**TOWN OF NEWBURGH  
PLANNING BOARD  
TECHNICAL REVIEW COMMENTS**

**PROJECT: CABRERA SUBDIVISION MODIFICATION**  
**PROJECT NO.: 18-24**  
**PROJECT LOCATION: SECTION 17, BLOCK 2, LOT 31.2 & 31.3**  
**REVIEW DATE: 14 DECEMBER 2018**  
**MEETING DATE: 20 DECEMBER 2018**  
**PROJECT REPRESENTATIVE: TALCOTT ENGINEERING/CHARLES BROWN**

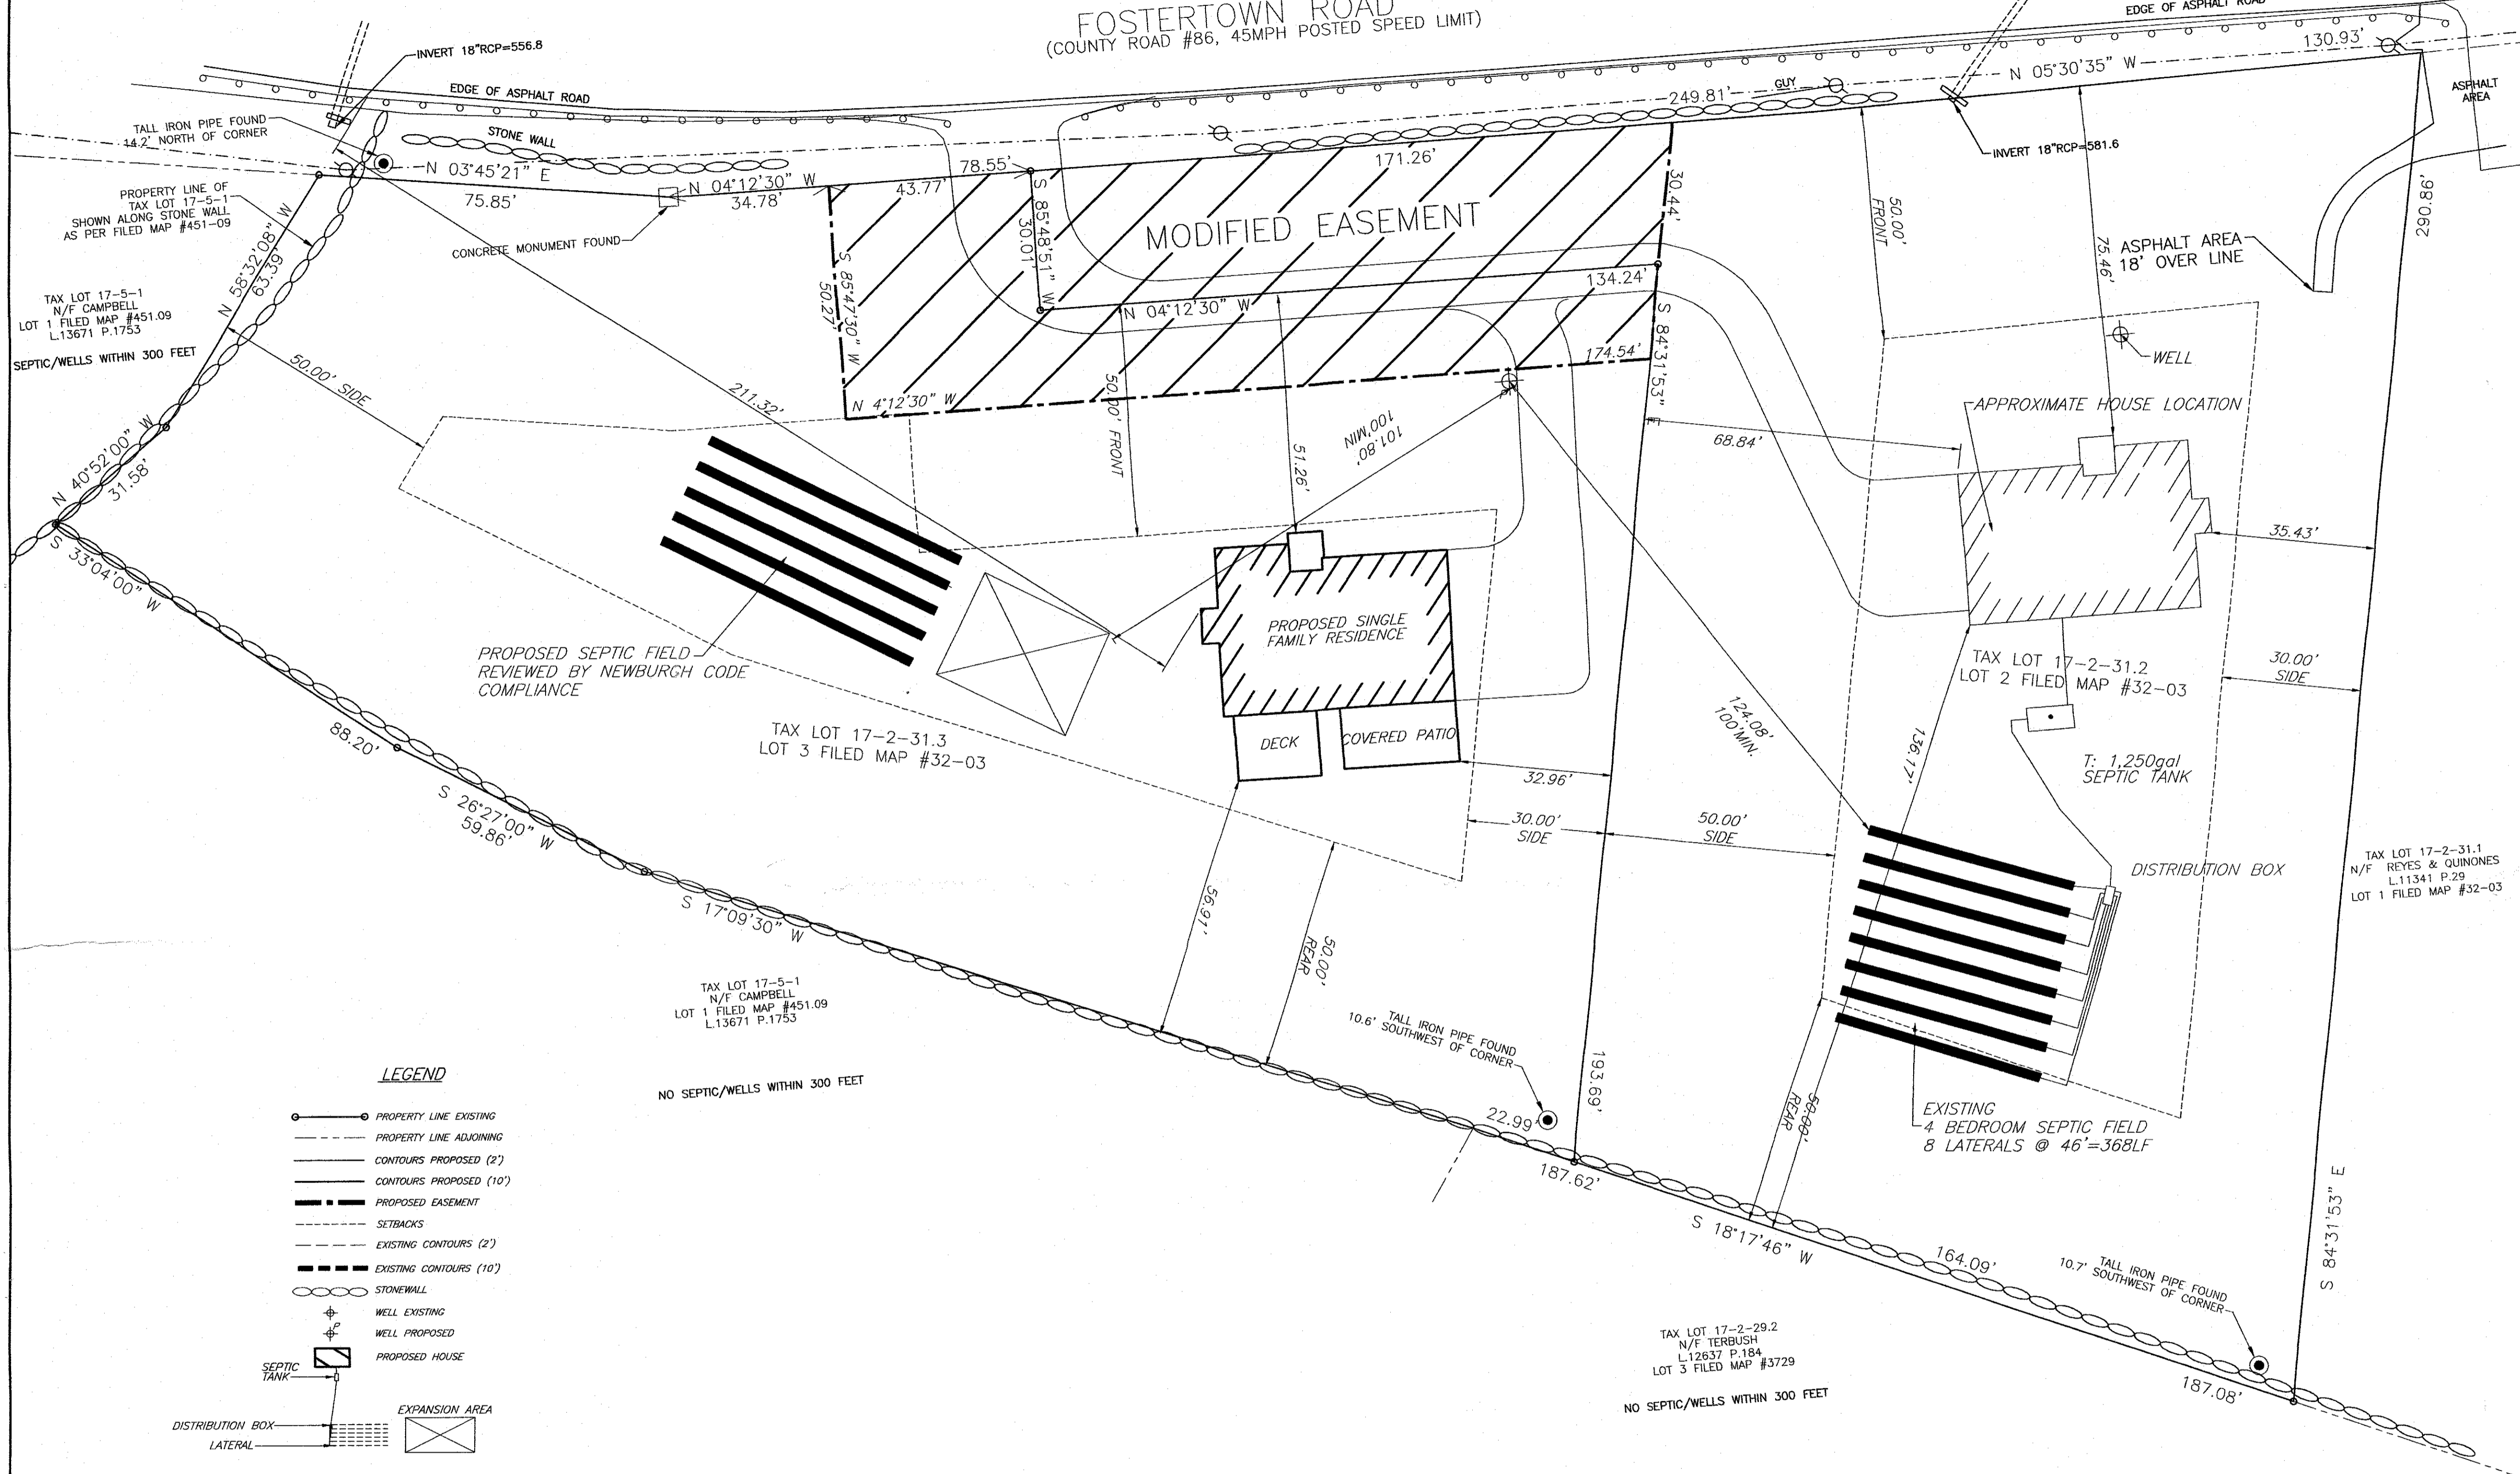
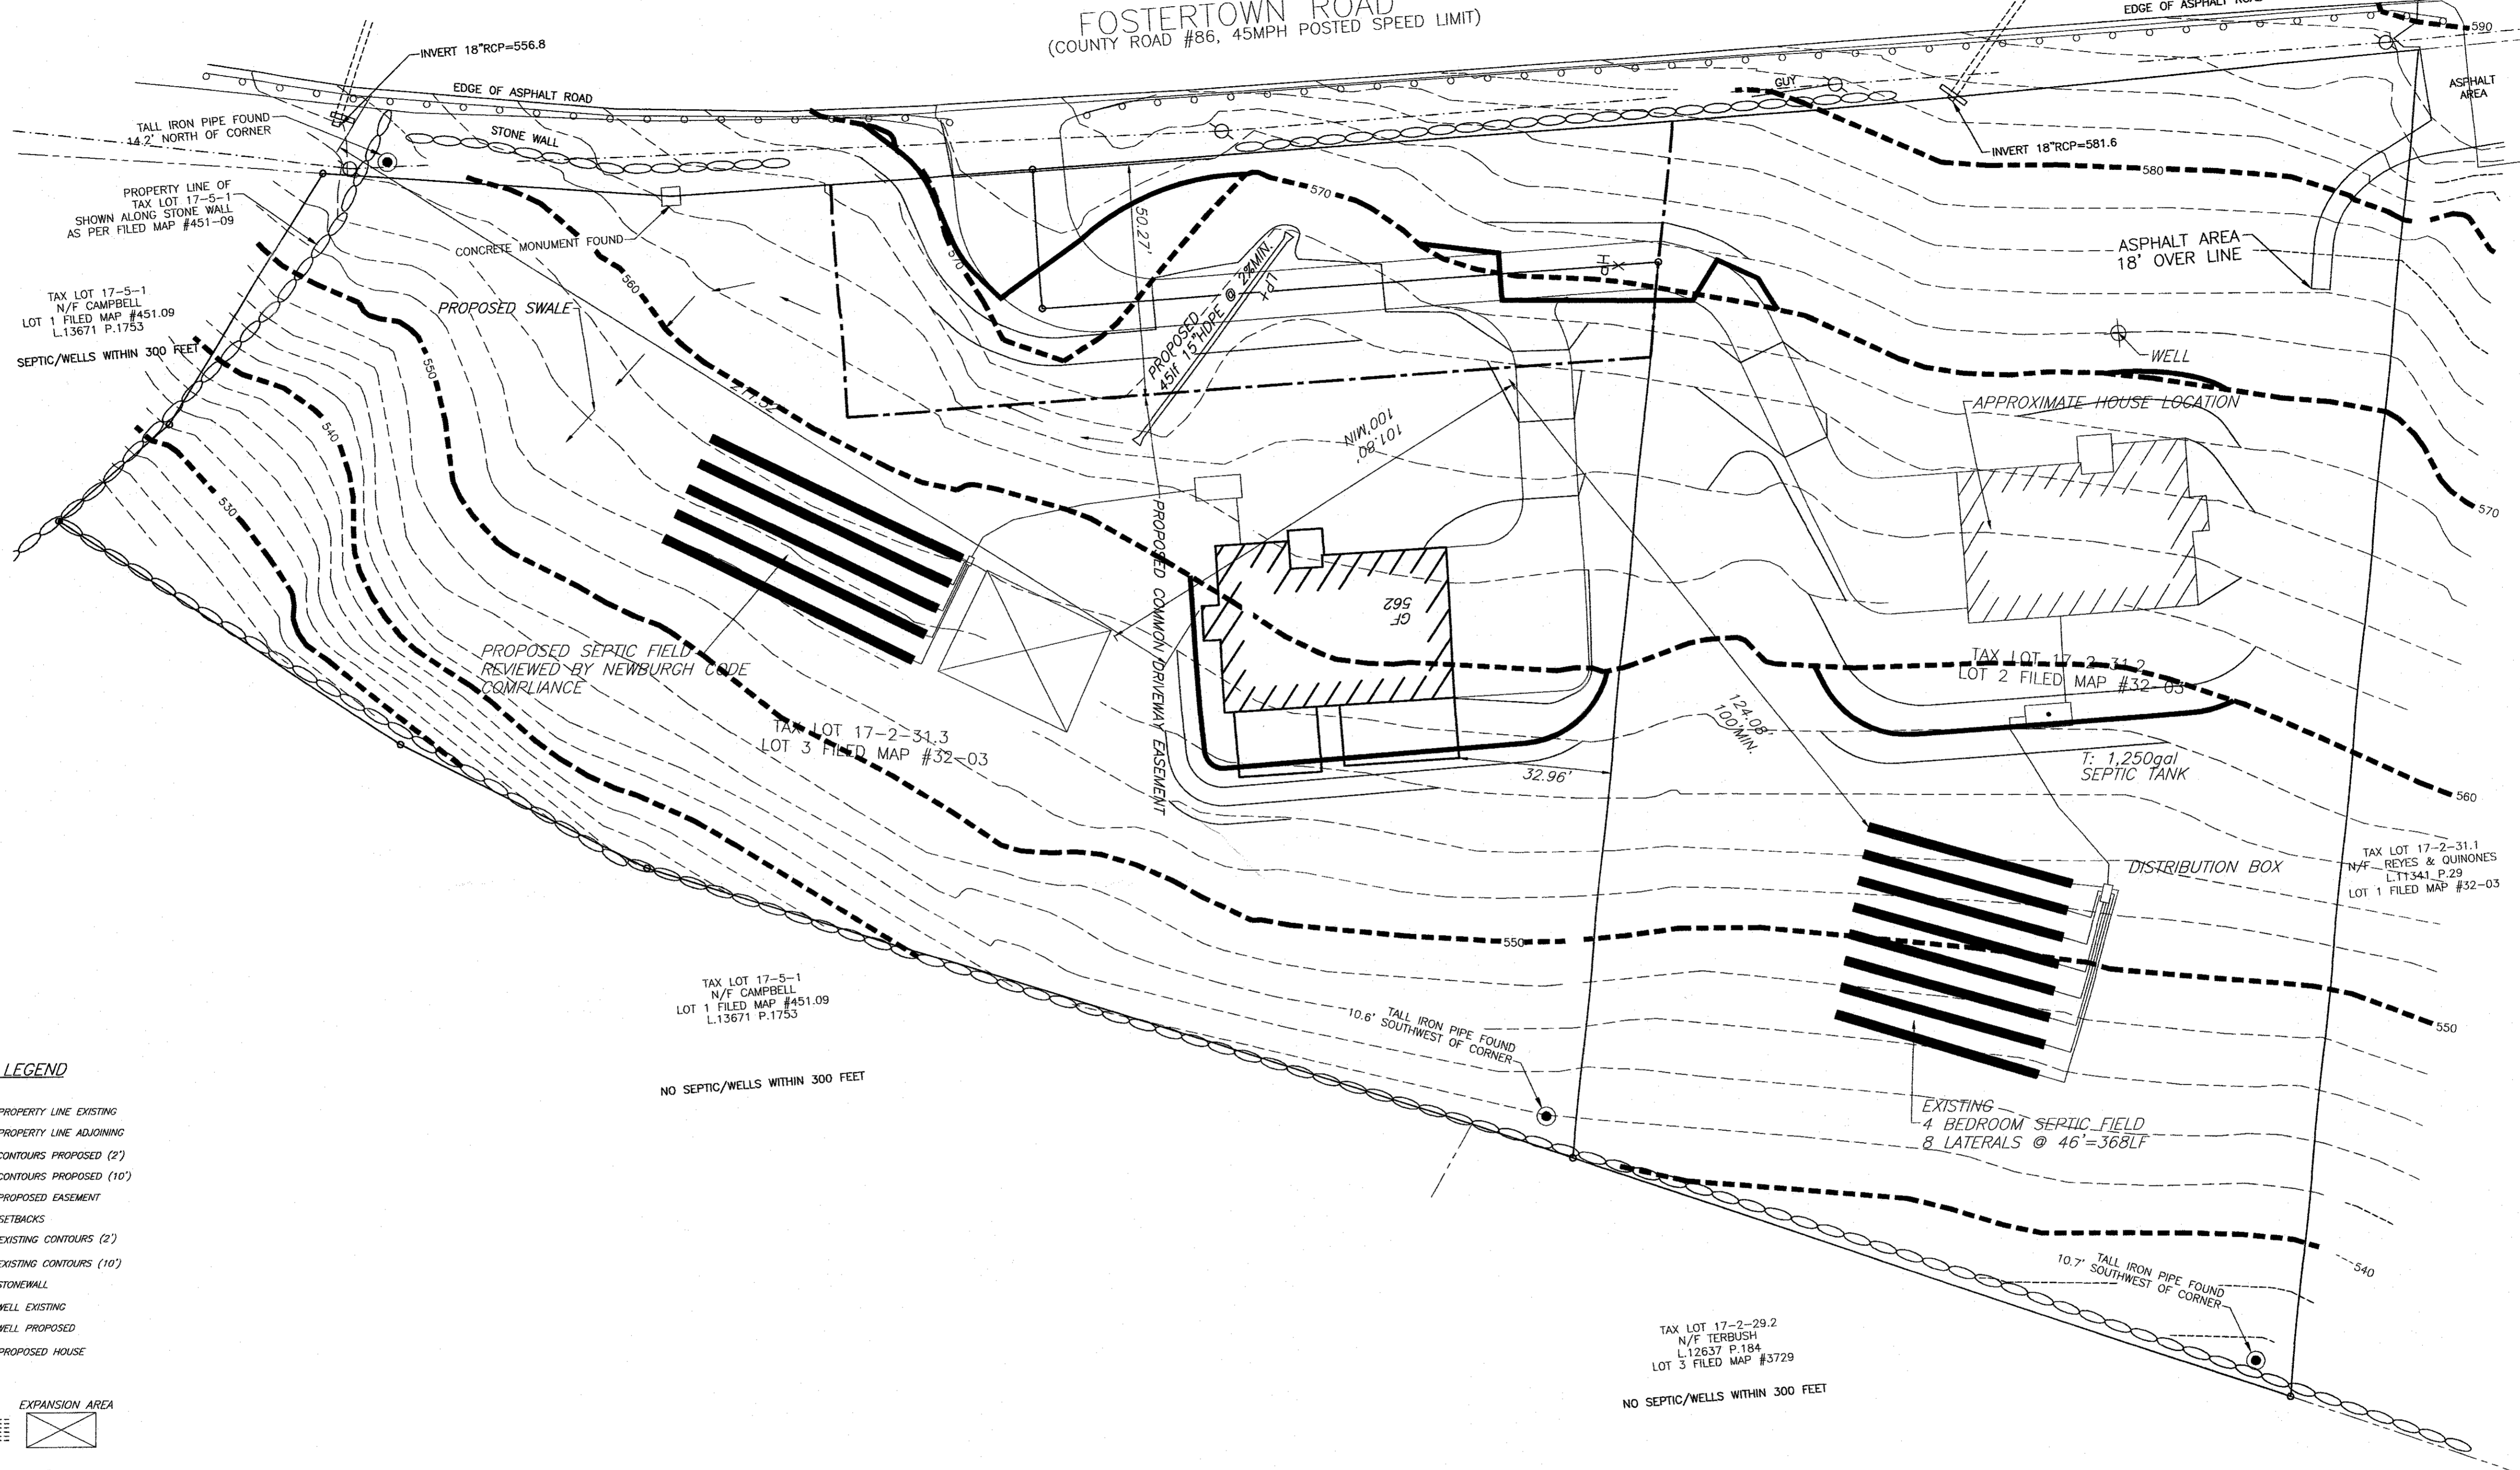
4. A proposed swale is identified at the new 15 inch HDPE, which crosses both of the lots. It appears that an easement for the swale as well as the drainage pipe may be required. Grading for the swale should be depicted as current topography would allow the discharge from the proposed pipe to cross the septic and reserve area.

5. The original plan contained a proposed drainage easement to County of Orange which should be depicted on the plans.
6. Mike Donnelly's review of the easement and maintenance agreement is required.
